**DEPARTMENT OF TRANSPORTATION  
STATE OF GEORGIA**

**FILE:** EDS-84(26), HPPN-EDS-84(27) & NHN-007-03(28) **OFFICE:** Eng. Services  
Ware County  
P.I. Nos.: 522770, 522780 & 522775  
S.R. 38/U.S. 84 Widening/Reconstruction and Bridge Replacement

**SUBJECT: IMPLEMENTATION OF VALUE ENGINEERING STUDY ALTERNATIVES**

# VALUE ENGINEERING STUDY REPORT RESPONSES

VE Comment A-3  
Layout comparison

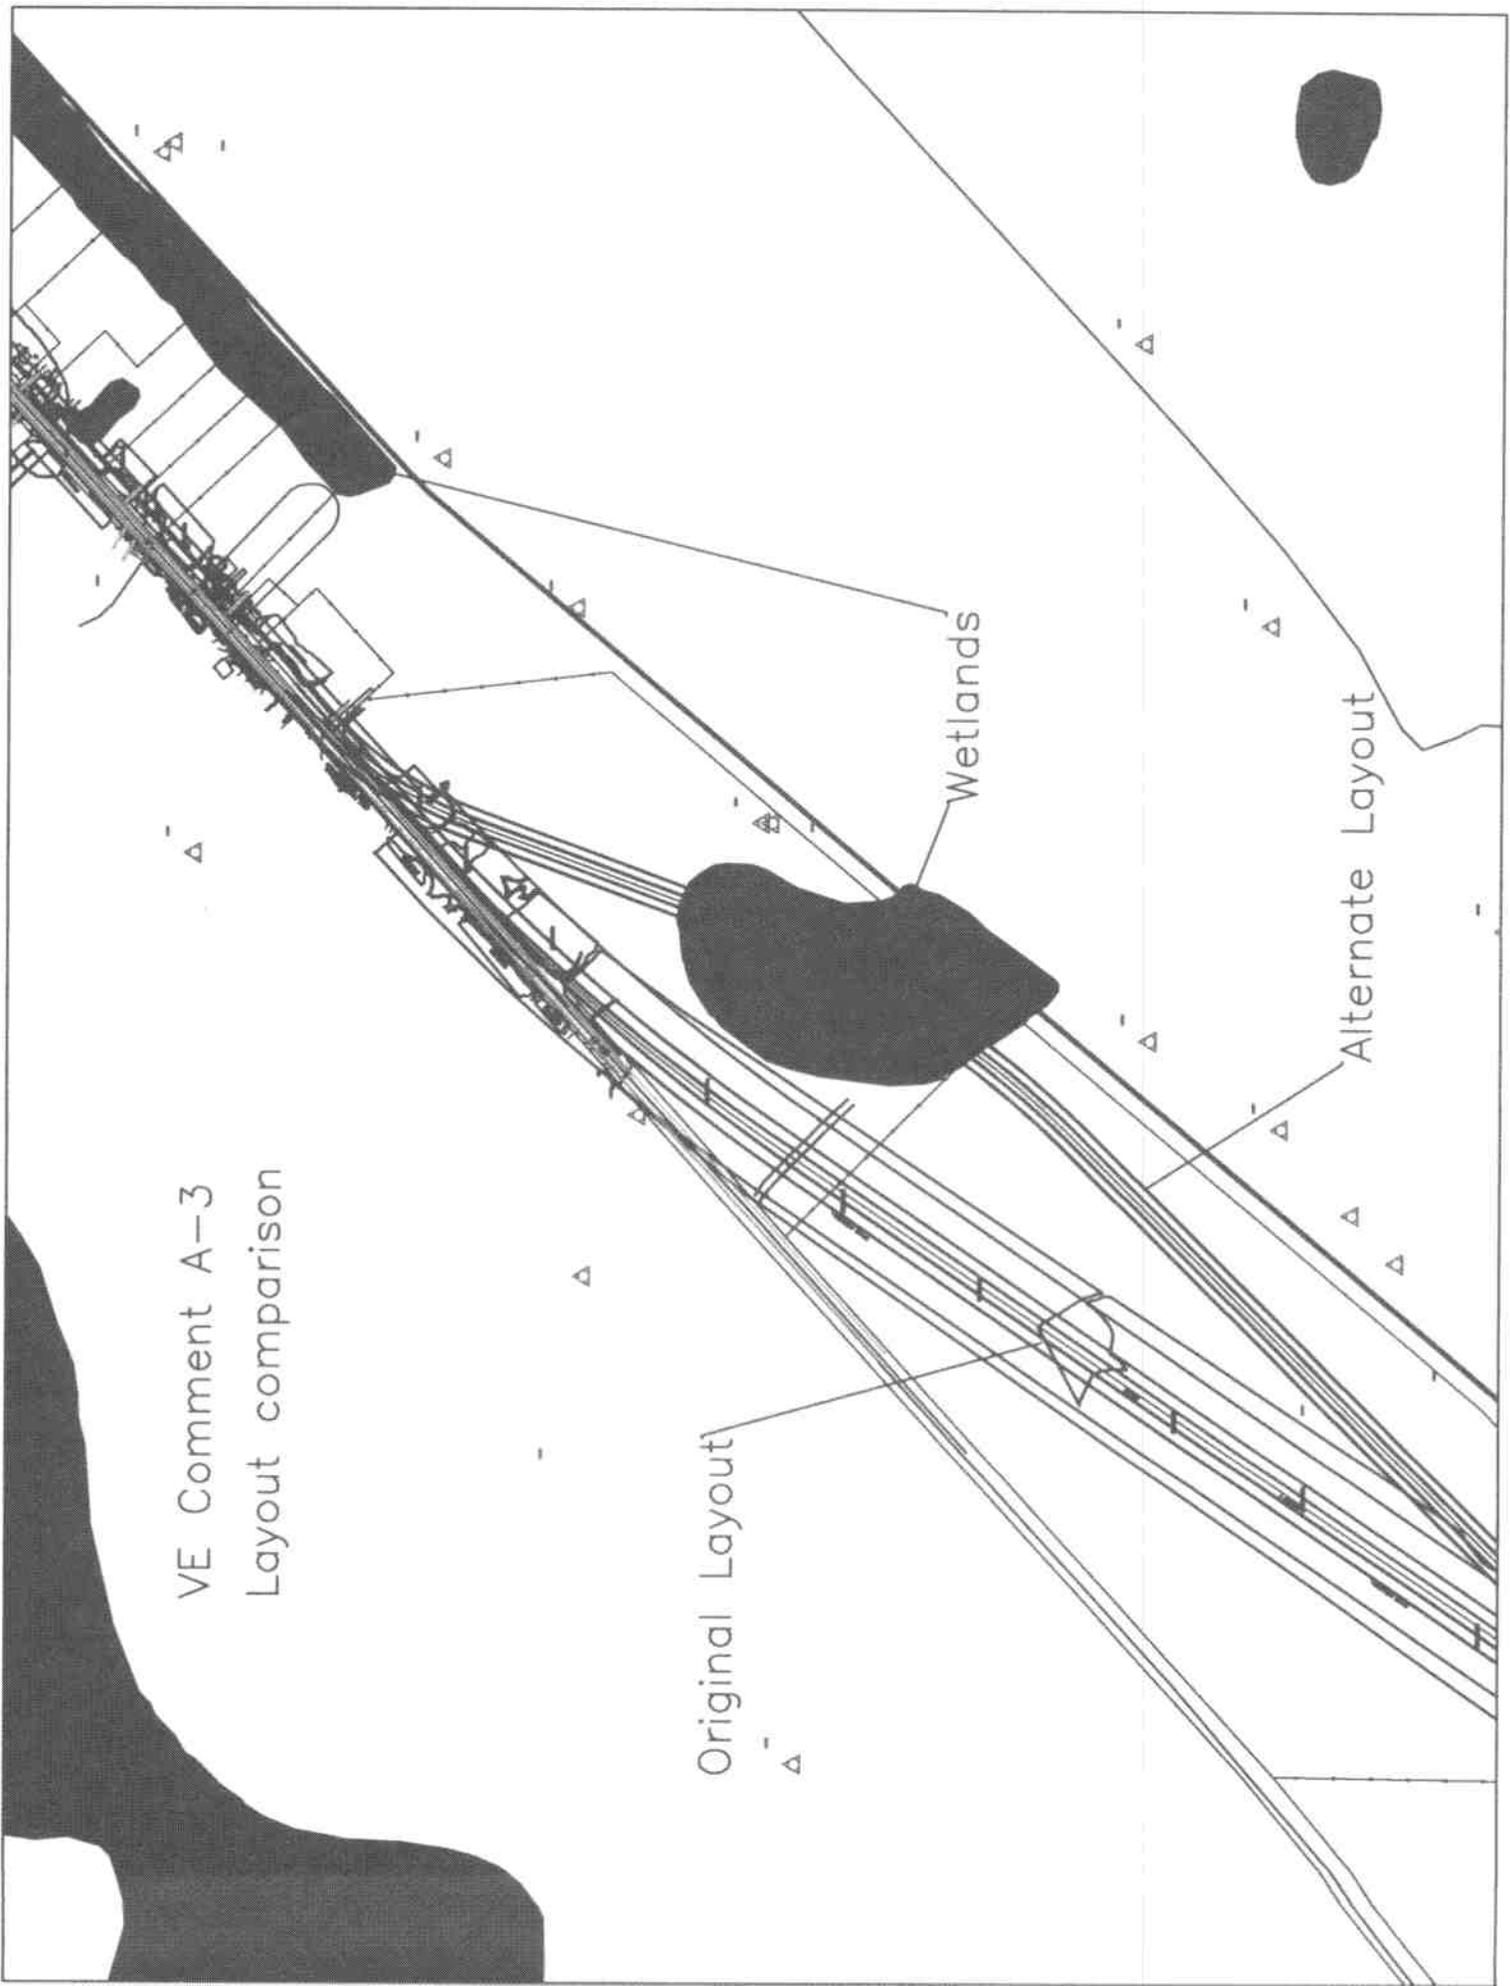
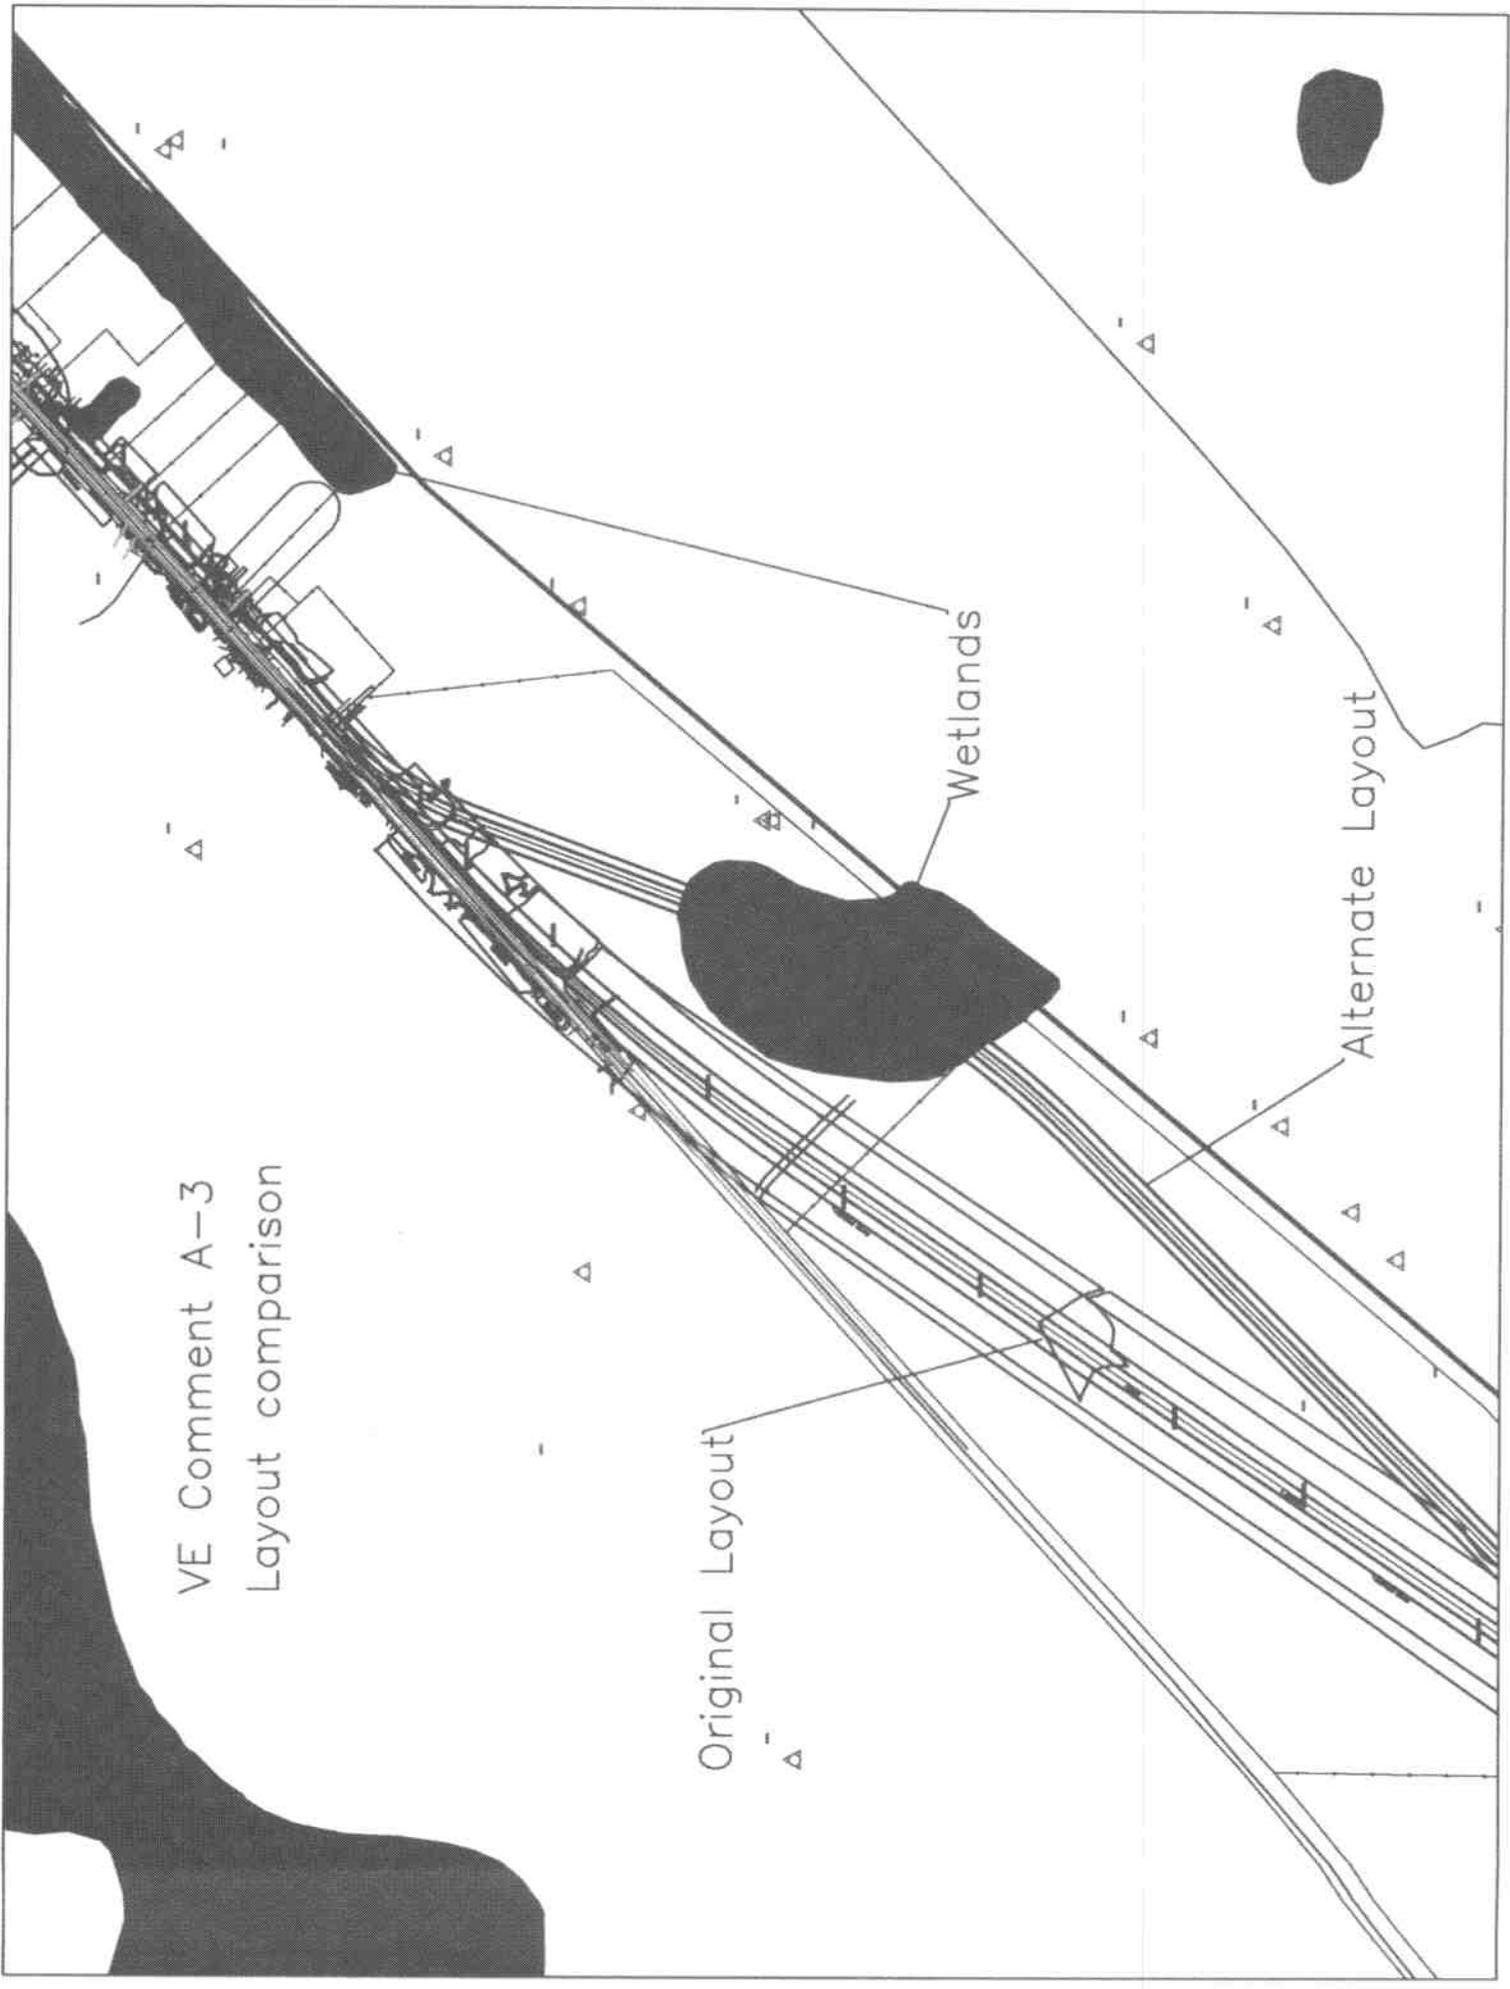
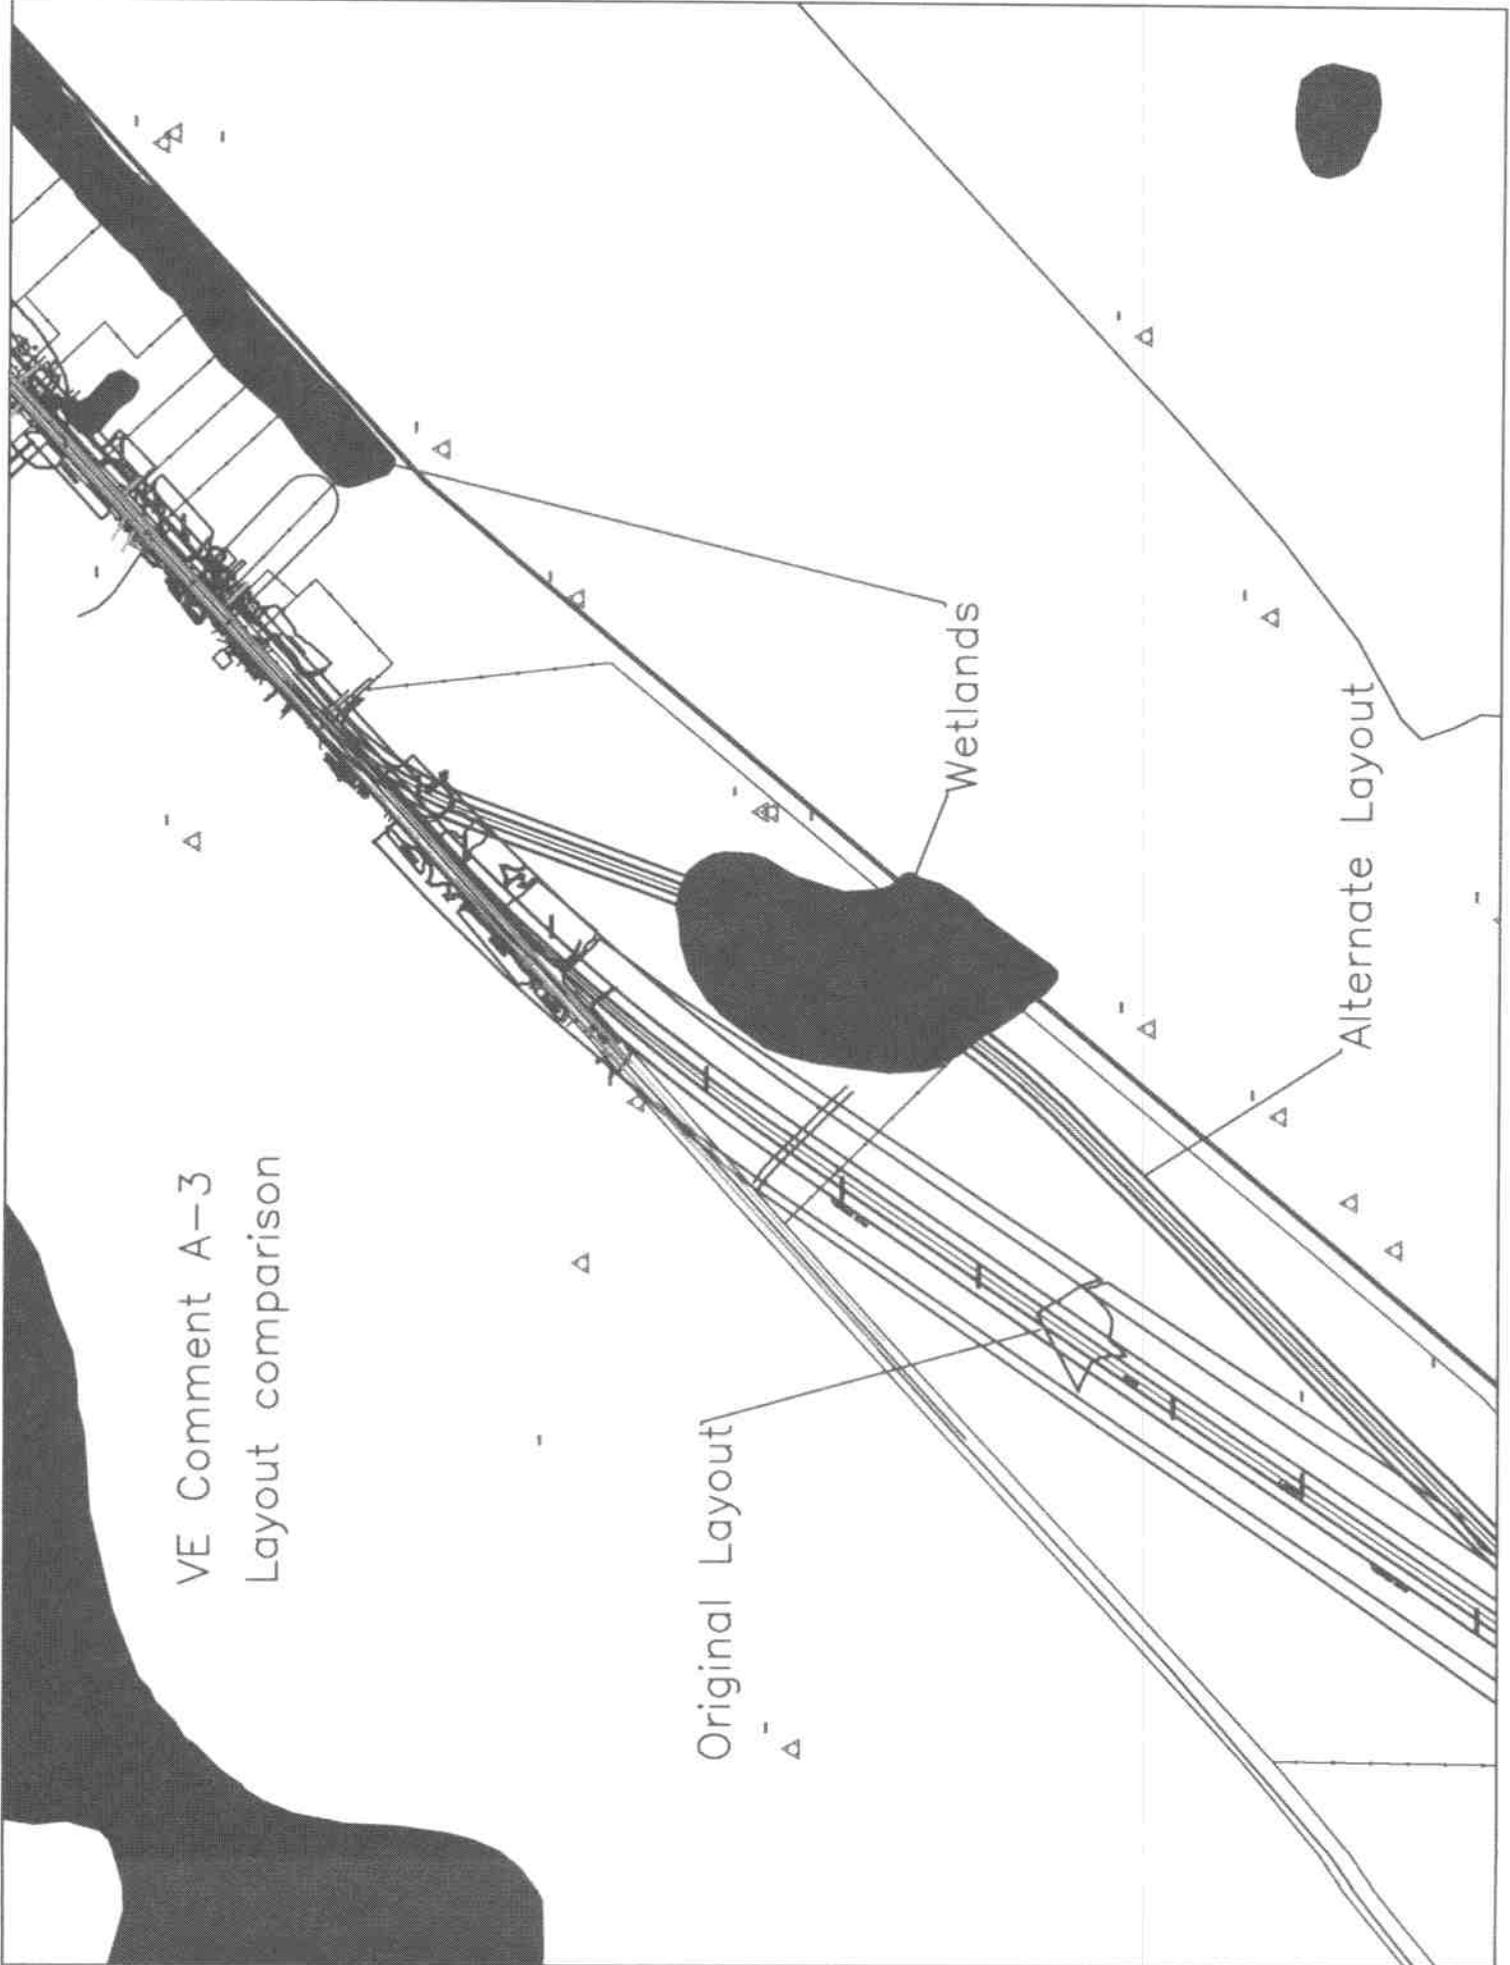
A-3 Reduce impacts to wetlands with new alignment at east end (increase wetlands identification) DS

The wetland areas shown on the plans are not inclusive of all areas other than those impacted by the original corridor. The impacts caused by the original design are significantly less than indicated on the VE Team's proposed alternate alignment. There are actually more wetlands closer to the CSX Railroad right-of-way in the path of this comment's proposed new alignment. (See attachment A-3)

Comment A-5 Analysis

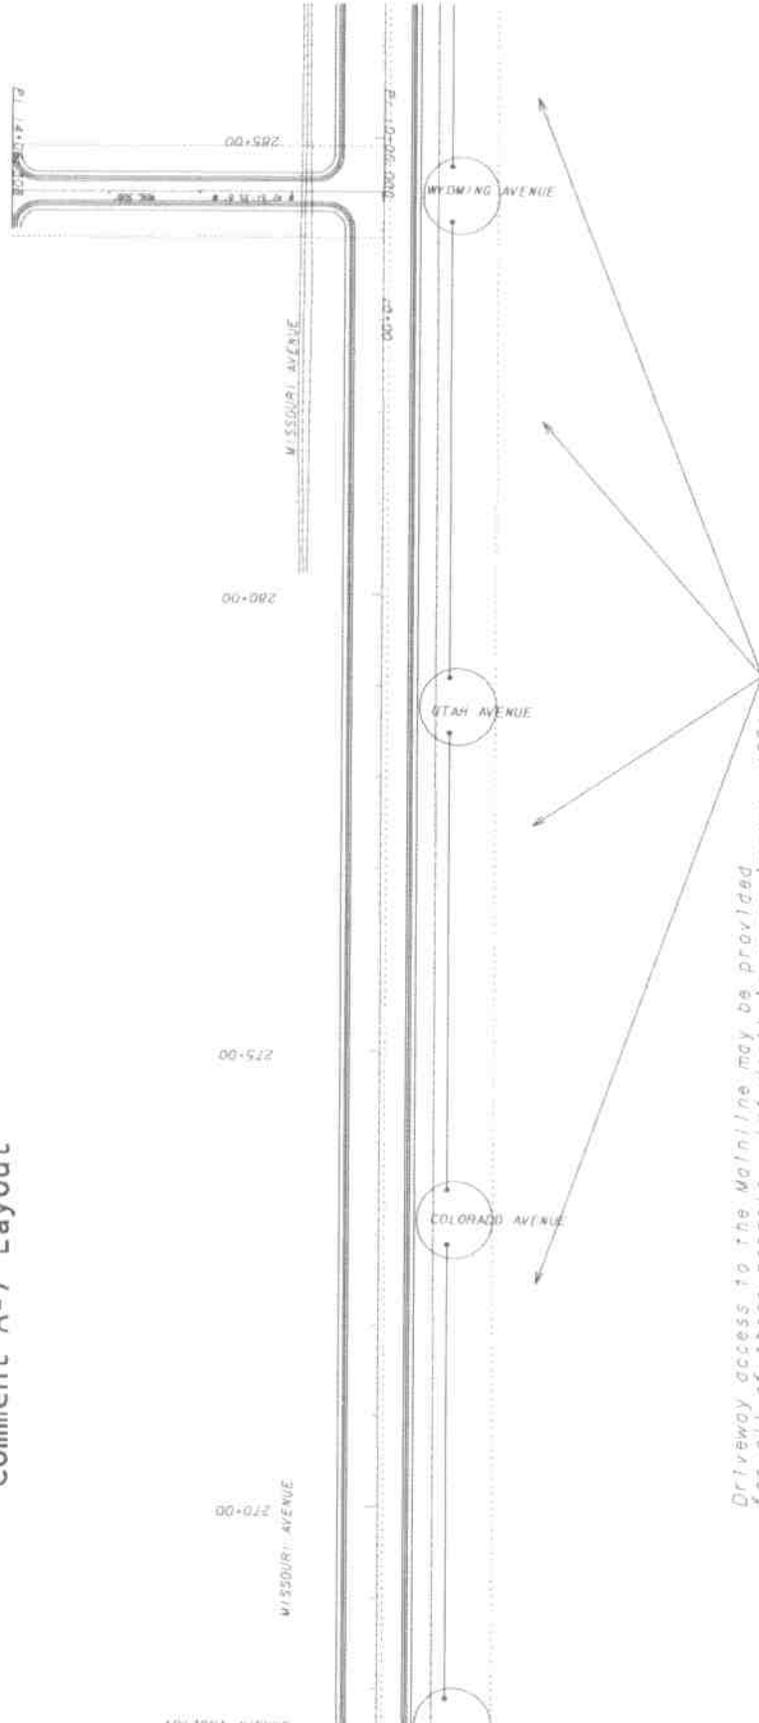
A-5 Build road adjacent to utility corridor DS

This is not a viable suggestion due to significant increases in required right-of-way, labor, and materials necessary to construct the entire roadway on new location. The projected cost increase for the just additional required right-of-way and base & paving is \$4,891,930. (See attachment A-5) Additionally, unknown environmental impacts hold potentially higher impacts than the existing corridor.
